**APPLICATION FOR RECONFIGURING A LOT (1 LOT INTO 2 LOTS) – RESPONSE TO INFORMATION REQUEST (RL/127/2025)**
**31 BAHRS SCRUB ROAD, BAHRS SCRUB, QLD 4207 (LOT 1 ON RP162767)**

On behalf of our Client, Flynn Nune Developments 6 Pty Ltd, and in accordance with the provisions of the Planning Act 2016, please find enclosed our response (sewer related items only) to Council's Further Information Request dated 18<sup>th</sup> of March 2026 and associated documentation for the abovementioned site.

2.1.4. Show the preferred sewerage concept and catchment plan in accordance with Figure 1 below:

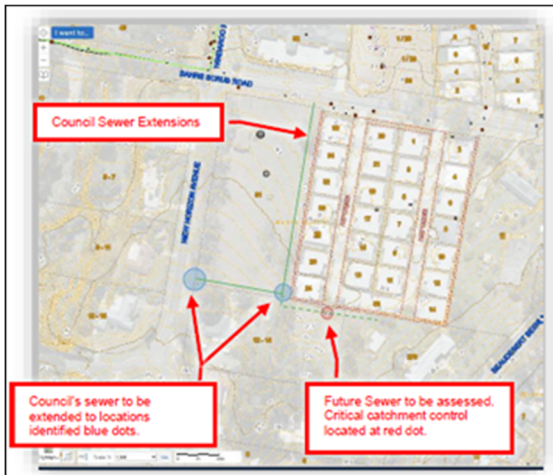
Council Request	Applicant's Response
<b>4. WATER DEVELOPMENT SERVICES</b>	
<b>Sewer</b>	
<p>2.1. Provide an amended concept servicing plan that shows the following:</p> <p>2.1.1. Extend Council's existing sewerage network in Bahrs Scrub Road along the eastern boundary of proposed Lots 1 and 2, to the south-eastern corner of Lot 2 for the control of the upstream catchment. This sewer pipe must be located within an easement;</p> <p><i>Advice Note: The proposed alignment in the road reserve of New Horizon Avenue is not supported due to the resulting sewer main depths (deep sewers – greater than 3.5m) and should be located within the subject site. The provision, design, construction and location of the proposed sewerage infrastructure must demonstrate compliance with the following requirements of PO2 of the Infrastructure code:</i></p> <ol style="list-style-type: none"> <li>i. Protects existing and planned infrastructure networks;</li> <li>ii. Services proposed development;</li> <li>iii. Integrates with existing and planned infrastructure networks;</li> <li>iv. Delivers a standard of service that is efficient and equitable;</li> <li>v. Minimises the cost to the community for</li> </ol>	<p>We refer Council to the accompanying sewer servicing concept layout and preliminary longitudinal section. This preliminary investigation demonstrates that the subject development, as well as the future reconfiguration of a lot of the adjacent property to the south, can be serviced via the existing sewer main within the Bahrs Scrub Road road reserve via a branch main along the site frontage within the New Horizon Avenue road verge fronting the site and provide council with unimpeded access to this service in the future.</p> <p>The majority of the conceptual sewer main within New Horizon Avenue will be less than 3.5m depth, however a small section of this main will exceed these depths all of which is in accordance with the South East Queensland Water Supply and Sewerage Design and Construction Code. This is due to the sewer crossing the existing overland flow path within the adjacent property between structures 7/101 and 8/101 which will most likely be filled once the neighbouring site is developed and intern this section can be made shallower.</p> <p>Forcing this sewer main to go through private</p>

2.1.2. Provide easements in accordance with the SEQ WS&S D&C Code, centrally located over the proposed sewerage infrastructure;

2.1.3. Remove reference to 'trunk' sewer infrastructure

Advice Note: The proposed 150mm diameter sewer extension is non-trunk infrastructure.

property, in particular the subject site, will impact the future developable area as a result of the sewer depth and ensuing easement widths. This will also ultimately hinder Council's ability to access and service the main, therefore we have progressed with having the proposed sewer main within the verge.

We note that Council have requested easements shown over the proposed sewer main where within private property, however as this is just a concept plan, and until such time that detailed design is carried out and sewer depths finalised, easements will be left off the concept plan.

All references to the proposed sewer main being trunk infrastructure have been removed.
